SUPPLEMENTARY ENVIRONMENTAL IMPACT STATEMENT

Gold Coast International Marine Precinct
Shipper Drive, Coomera

This SEIS document relates to the Gold Coast International Marine Precinct (GCIMP) Project.

Figure 14 - Foxwell Road / Shipper Drive Intersection Template

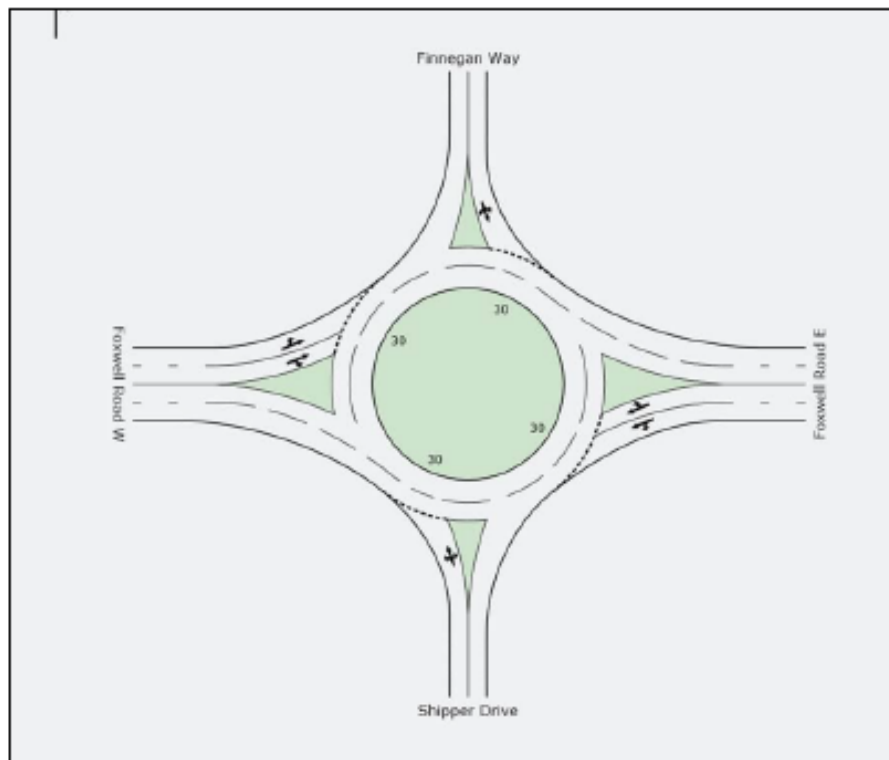
GCCC noted the adopted intersection layout for Foxwell Road / Shipper Drive used for SIDRA modelling identifies separate right, through and left lanes. Therefore, GCCC have requested the template be adjusted to reflect the existing road environment.

The intersection template adopted for SIDRA modelling purposes is shown in Figure 14. The adopted layout reflects and is consistent with the current intersection configuration that exists. As such, no amendments to the template have been made.

Figure 15 - GCIMP Traffic Distribution

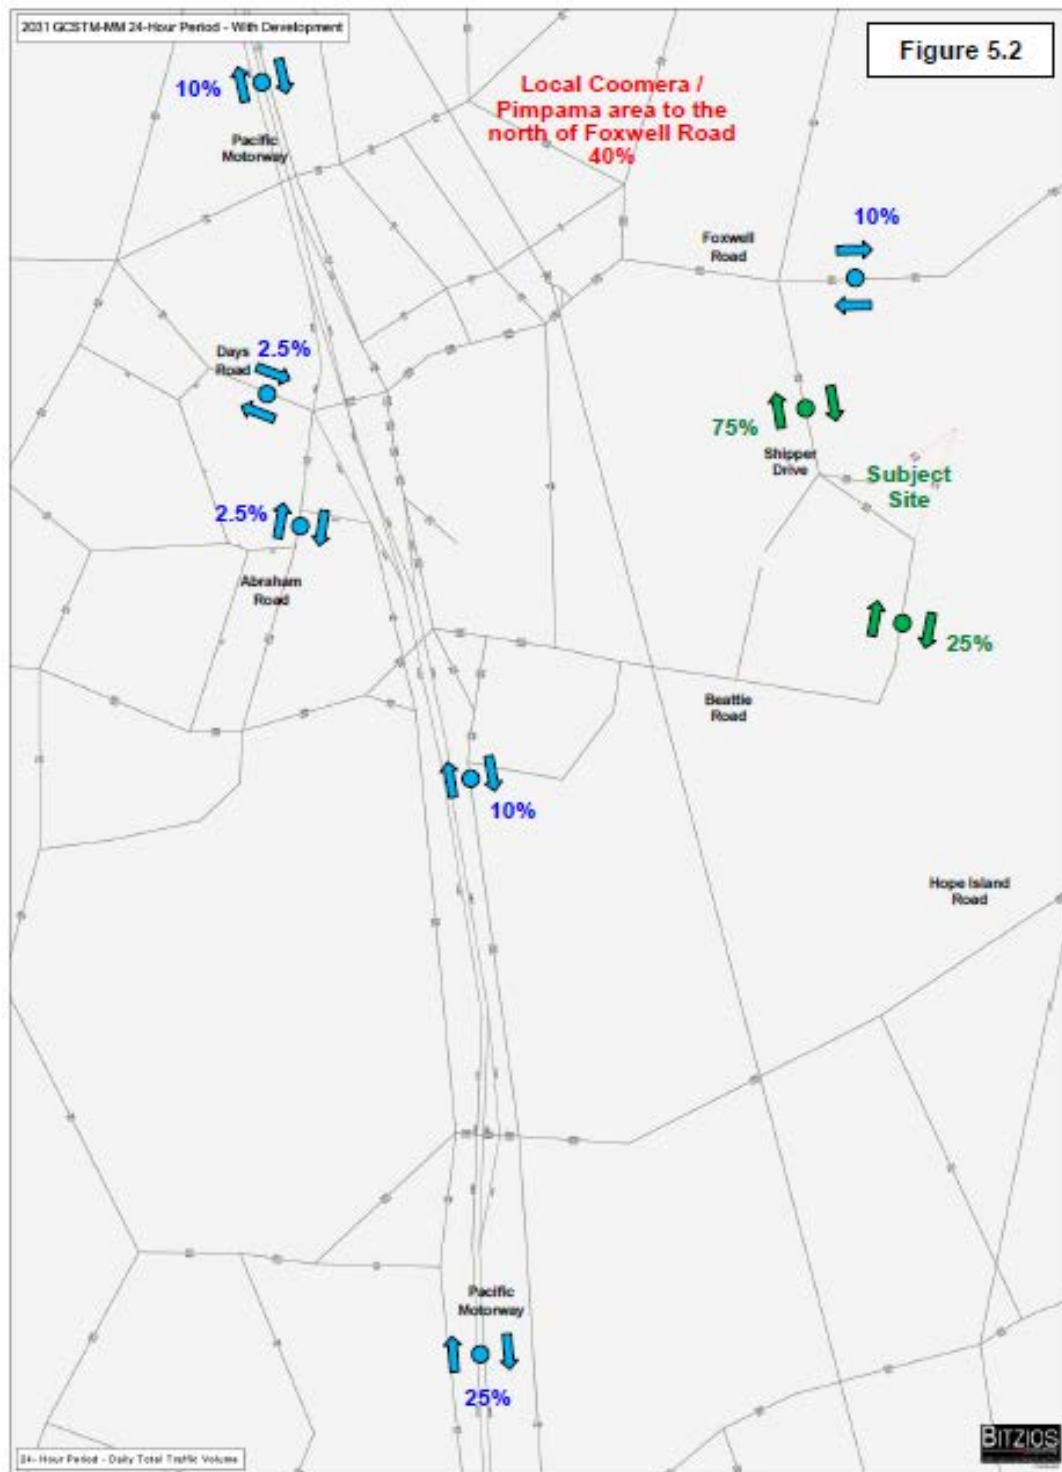
GCCC questioned within their submission the trip generation rate applied to the Water Front Industry Use proposed within the GCIMP. GCCC stated the applicable Peak Trip generation for Waterfront Industry is 0.9 peak hour trips per 100m² GFA and Daily Trip generation is 9 trips per 100m² GFA.

Based on the methodology utilised by Bitzios and outlined within section 5.2 of CRG's Supplementary Traffic Impact Assessment contained in Volume 2, Appendix 8 of the SEIS, the resultant distribution of traffic through the road network is approximated in Figure 15 below.

Figure 16 - Coomera LAP Precinct Map (Source: GCCC Planning Scheme 2003)

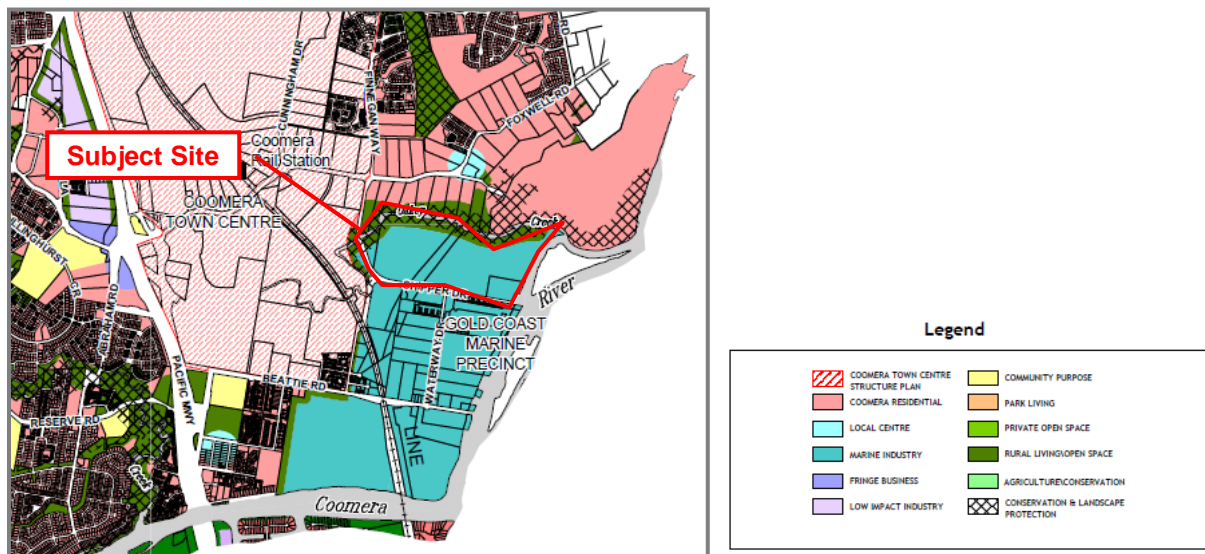
It has become apparent that DTMR have failed to take into account that the majority of the project site is currently designated as a Marine Industry Precinct in the Coomera LAP under the GCCC Planning Scheme as identified in Figure 16.

Figure 16 - GCIMP Traffic Distribution

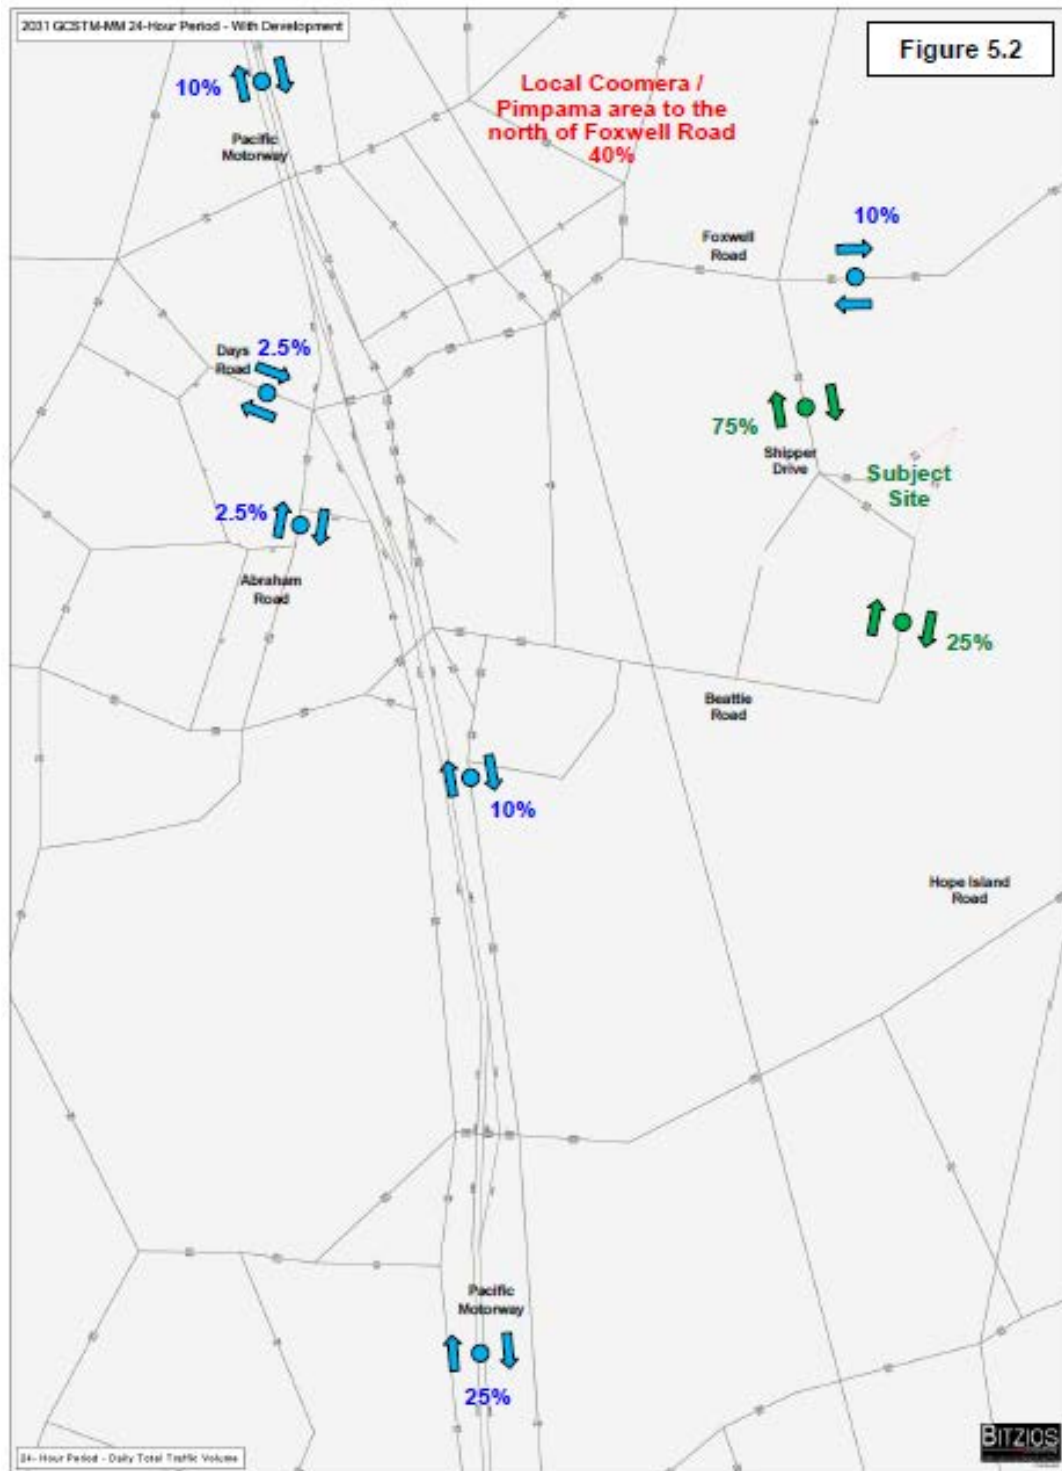
GCCC questioned within their submission the trip generation rate applied to the Water Front Industry Use proposed within the GCIMP. GCCC stated the applicable Peak Trip generation for Waterfront Industry is 0.9 peak hour trips per 100m² GFA and Daily Trip generation is 9 trips per 100m² GFA.

Based on the methodology utilised by Bitzios and outlined within section 5.2 of CRG's Supplementary Traffic Impact Assessment contained in Volume 2, Appendix 8 of the SEIS the resultant distribution of traffic through the road network is approximated in Figure 16 below.

Figure 17 - Coomera LAP Precinct Map (Source: GCCC Planning Scheme 2003)

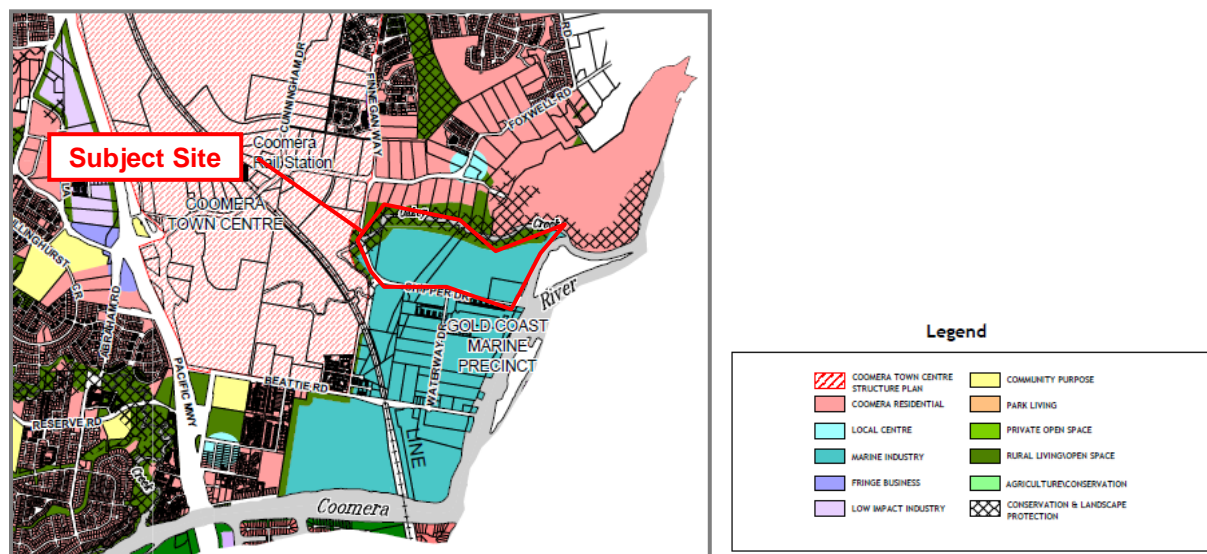
It has become apparent that DTMR have failed to take into account that the majority of the project site is currently designated as a Marine Industry Precinct in the Coomera LAP under the GCCC Planning Scheme as identified in Figure 17.
